Access Compliance Report

Public Rights-of-Way

Intersection ID: N/A	Main Street: E MARTIN LUTHER KING JR BV	Cross Street: S DAVIDSON ST	Location: W
ADA ID: 8DD2854A2C6B	Ramp Type: Perpendicular Diagonal	Initial Pass/Fail: Fail	Overall Compliance: No
Severity Score: 21.25			
Codes/Mitigation Info/Possible Solution		Field Measurements/Component Compliance

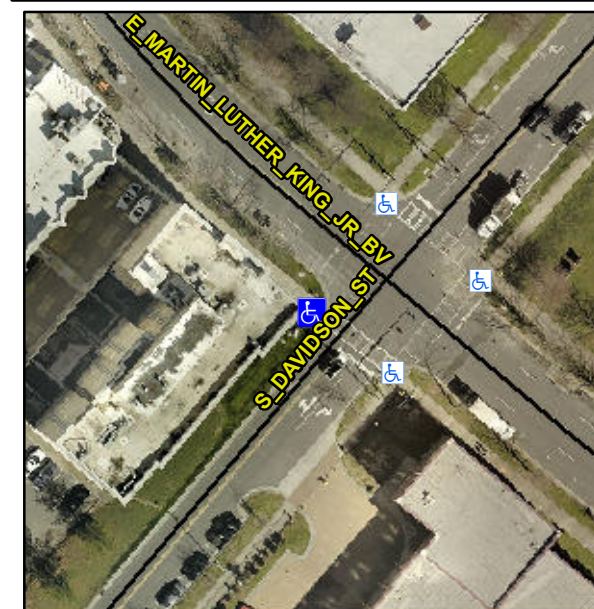
Not Found, R304.5.1, R304.2.2

Compliance	Description	Data	Compliance	Description	Data
N/A	Ramp Length (in)	62.0	No	Ramp Slope (%)	9.1
No	Ramp Width (in)	47.0	Yes	Ramp XSlope (%)	1.2
N/A	Flare Type LT	N/A	N/A	Flare Type RT	N/A
N/A	Flare Slope LT (%)	N/A	N/A	Flare Slope RT (%)	N/A
N/A	Flare Traversable LT?	No	N/A	Flare Traversable RT?	No
N/A	Landing Length (in)	N/A	N/A	DWS Provided?	N/A
N/A	Landing Width (in)	N/A	N/A	DWS Contrast?	N/A
N/A	Landing Slope (%)	N/A	N/A	DWS Length (in)	N/A
N/A	Landing X Slope (%)	N/A	N/A	DWS Full Width?	N/A
N/A	Landing Curb? (Y/N)	N/A	N/A	DWS Offset (in)	N/A
N/A	Shared Landing?	N/A			
N/A	Gutter Ponding?	N/A	N/A	Gutter Slope (%)	N/A
N/A	Gutter Lip Ht (in)	N/A	N/A	Gutter X Slope (%)	N/A
N/A	Painted X Walk1?	Yes	N/A	Painted X Walk2?	Yes
	X Walk 1 Direction	To SE		X Walk 2 Direction	To NE
N/A	X Walk 1 Width (in)	100.0	N/A	X Walk 2 Width (in)	111.0
	X Walk 1 Slope (%)	5.2		X Walk 2 Slope (%)	2.1
	X Walk 1 X Slope (%)	0.9		X Walk 2 X Slope (%)	3.6

Remove & Replace Curb Ramp With Two New Directional Ramps or Equivalent.
